## Executive Director's Recommendation

Commission Meeting: December 4, 2025

| <b>PROJECT</b><br><b>Fallen Journalists Memorial</b><br>300 Independence Avenue, SW<br>Washington, DC | <b>NCPC FILE NUMBER</b><br>8449   |
| <b>REVIEW AUTHORITY</b><br>Commemorative Works<br>per 40 U.S.C. § 8905                                | <b>APPLICANT'S REQUEST</b><br>Approval of preliminary site<br>development plans       |

Sidewalk widths to 15' - 0"

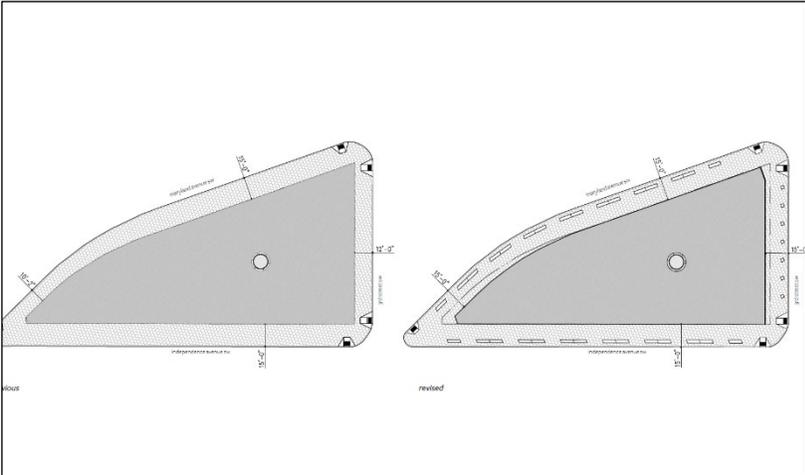
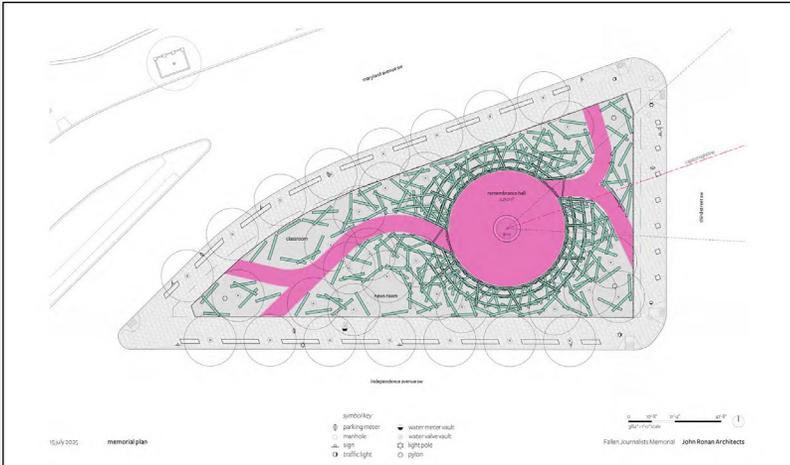
**Supports** the expansion of the sidewalk widths to 15 feet around the entire perimeter of the memorial site in response to the Commission's previous comments.

# Remembrance Hall

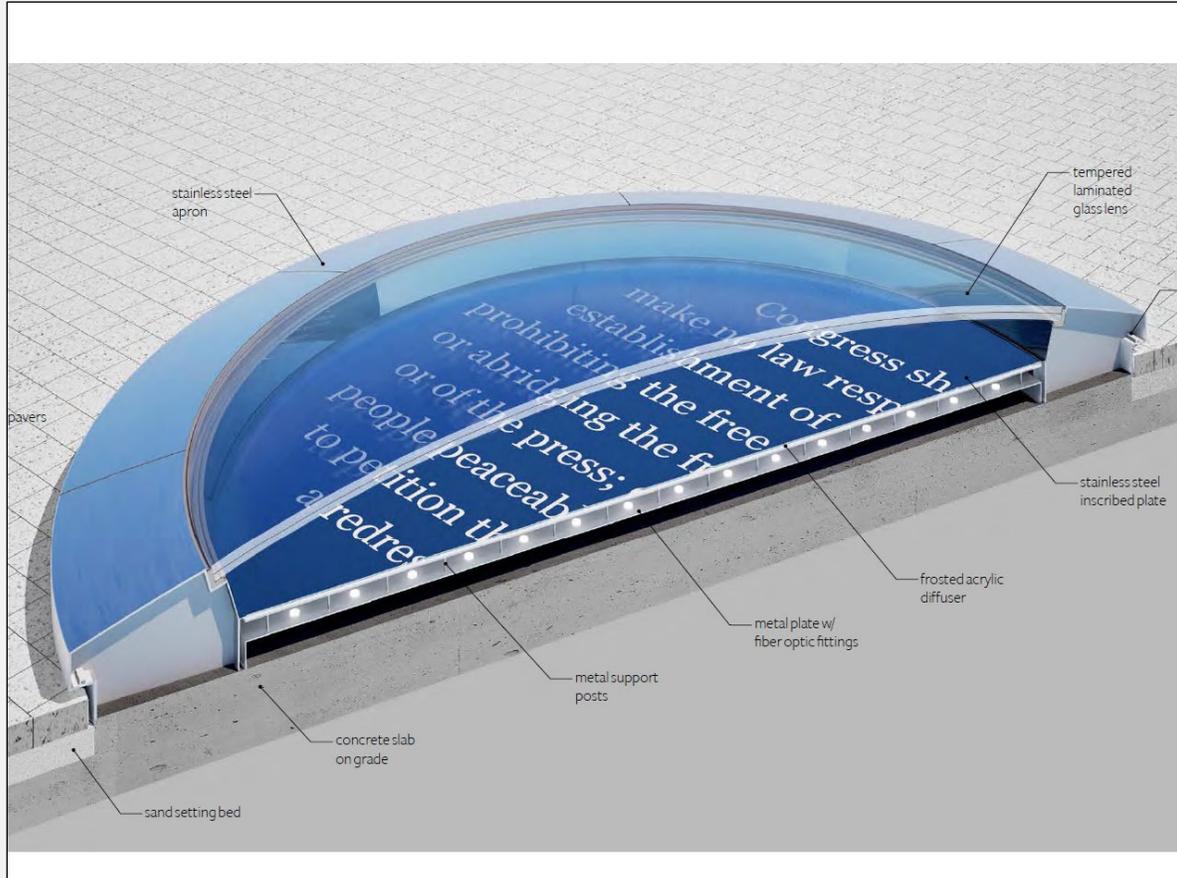
**Finds** the design of the Remembrance Hall creates a more formal experience within the larger memorial site, with the circular design of the memorial centered around a central lens element and views of the Capitol dome.

**Supports** the proposed addition of a second entryway into Remembrance Hall to help address better circulation throughout the entire memorial.

**Recommends** the applicant consider moving the east entryway to align with the view of the U.S. Capitol as viewed from the central lens element.

**Requests** the applicant to continue to evaluate the overall height of the Remembrance Hall to ensure that views to the U.S. Capitol Dome are appropriately framed once the entryway is aligned.

# Streetscape - Trees

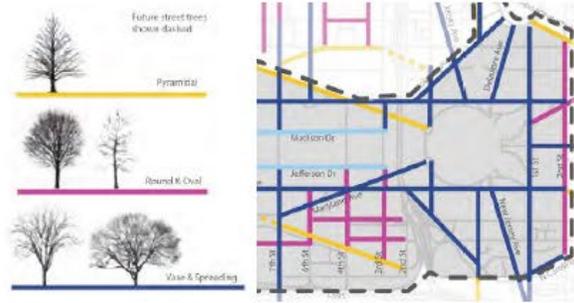
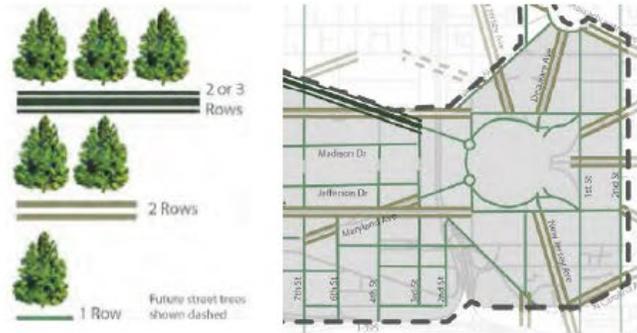
**Notes**, in response, the applicant has added two rows of street trees along Independence Avenue and selected two cultivars of honey locusts as the tree which is an approved "vase and spreading" tree in the Monumental Core Street Design Guidelines.

**Notes** in response to the Commission's comments, the applicant arranged the trees in more linear fashion along the perimeter of the site that fits into the streetscape and clustered more trees around the outside of the Remembrance Hall.

**Recommends** the applicant evaluate if more trees and other landscaping can still be added.

# Lighting

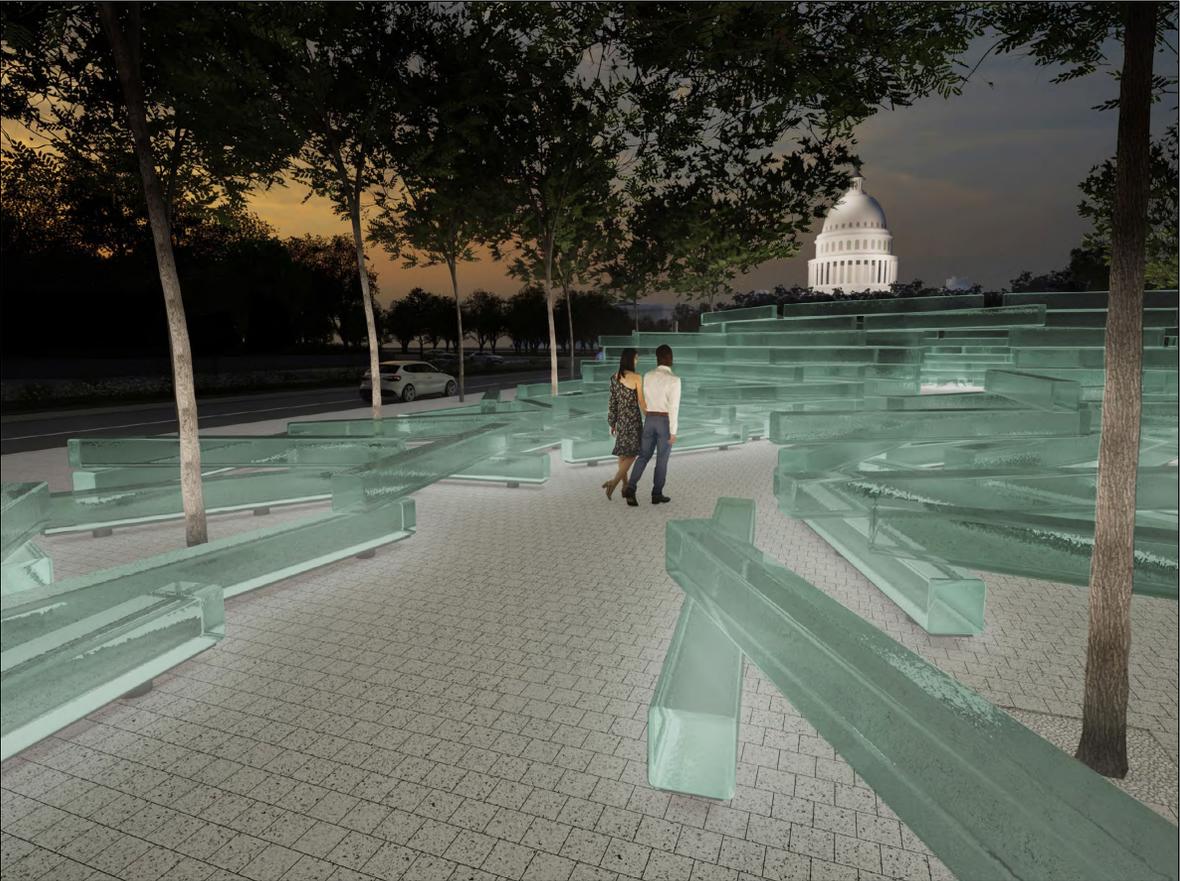
**Notes** the submission indicates the memorial lighting approach includes up-lit glass elements which would create a glow across the site.

**Recommends** the applicant to continue to refine the lighting study as design changes are made to ensure the proposed lighting levels remain appropriate with the hierarchy of surrounding buildings and memorials.

# Glass Elements

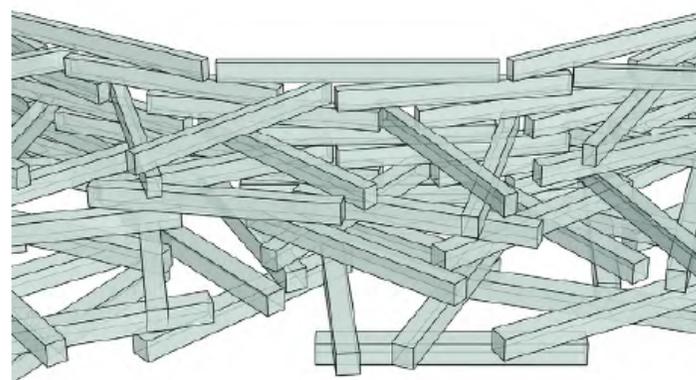
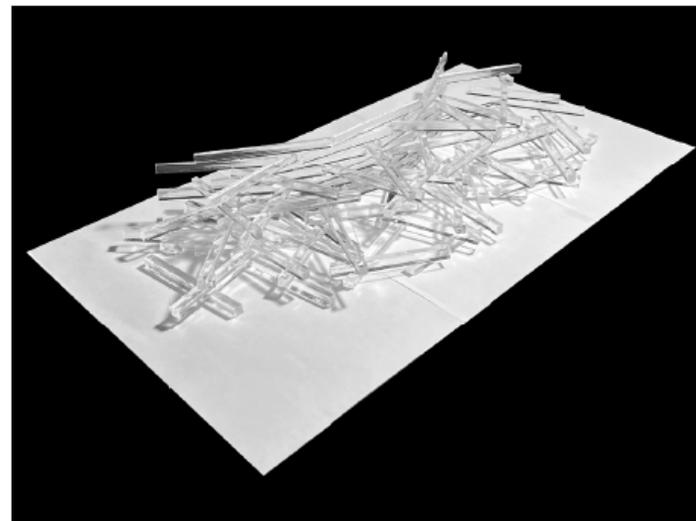
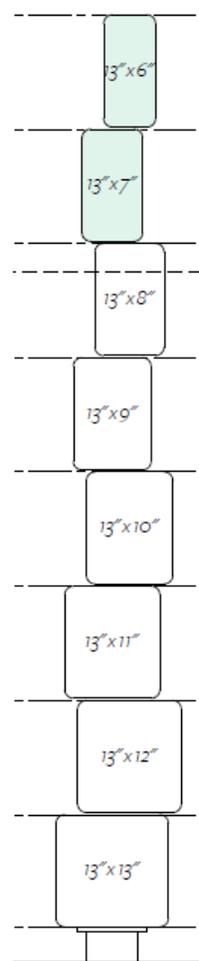
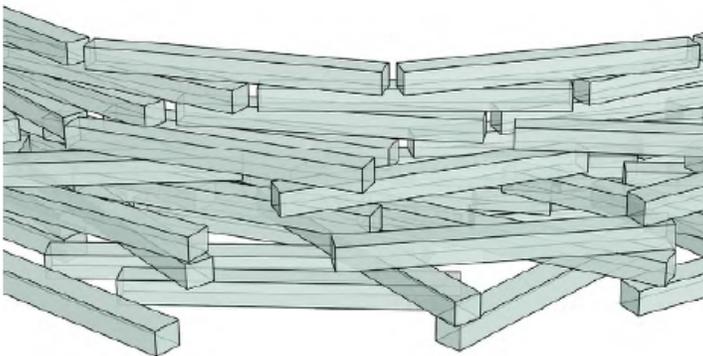
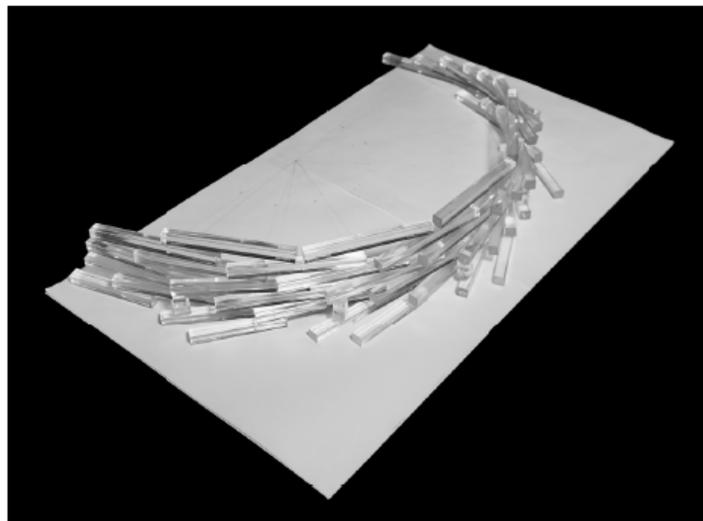
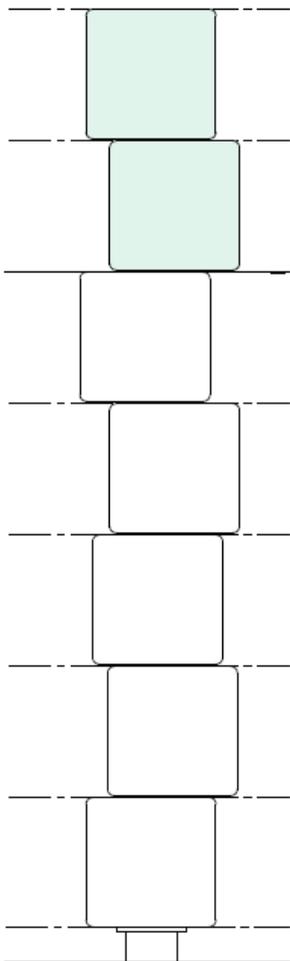
**Notes** the applicant selected glass elements as the primary commemorative material as it engages with themes of transparency, opacity, distortion, clarity, and light. Each glass element will be unique and slightly different, to represent the unique personal story of each journalist remembered here.

- The durability of the glass elements with car exhaust/smog, and how they will be maintained and cleaned;
- Continued refinement of how climbing and skateboarding will be addressed;
- Clearly state how the temporary event will happen on different surfaces without impacting the designed landscape in the median of Maryland Avenue.

# Skateboard Deterrence

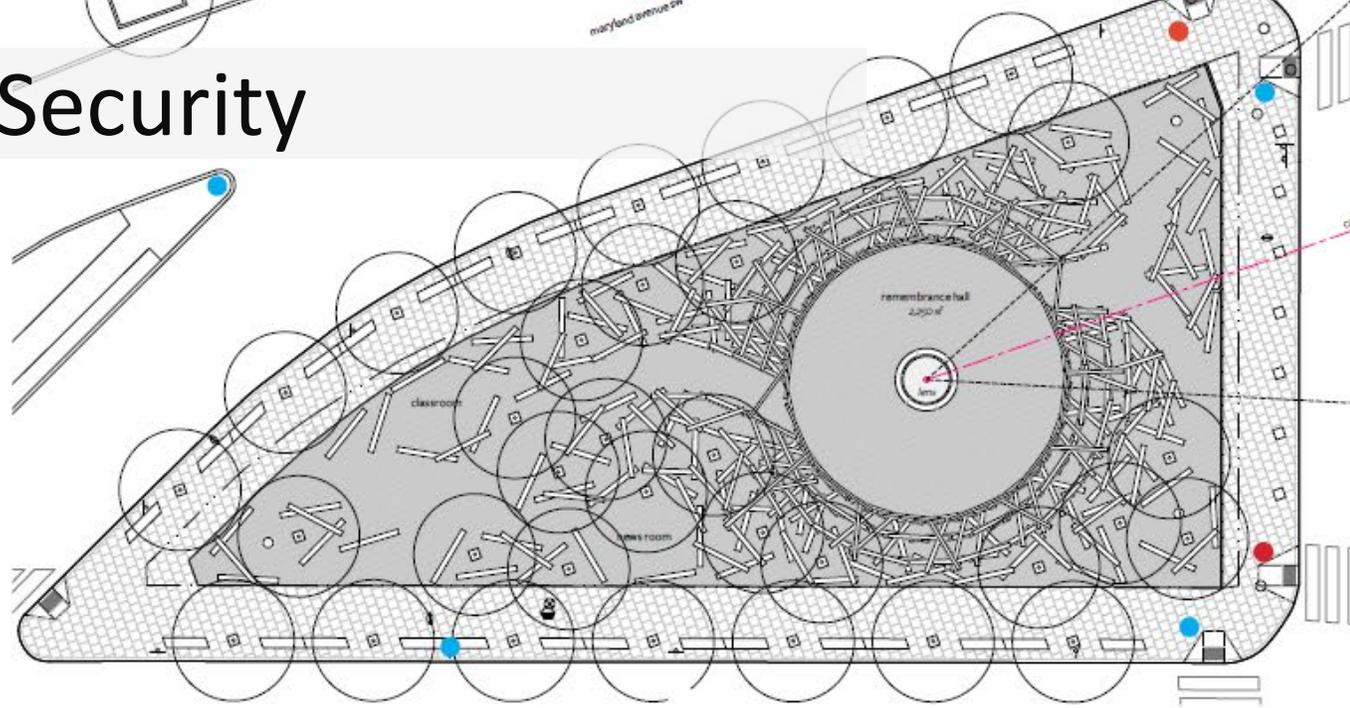
**Finds** the proposed skateboarding deterrence options may detract from the design and comfort for visitors.

**Requests** the applicant explore additional alternatives to deter skateboarding on the memorial.
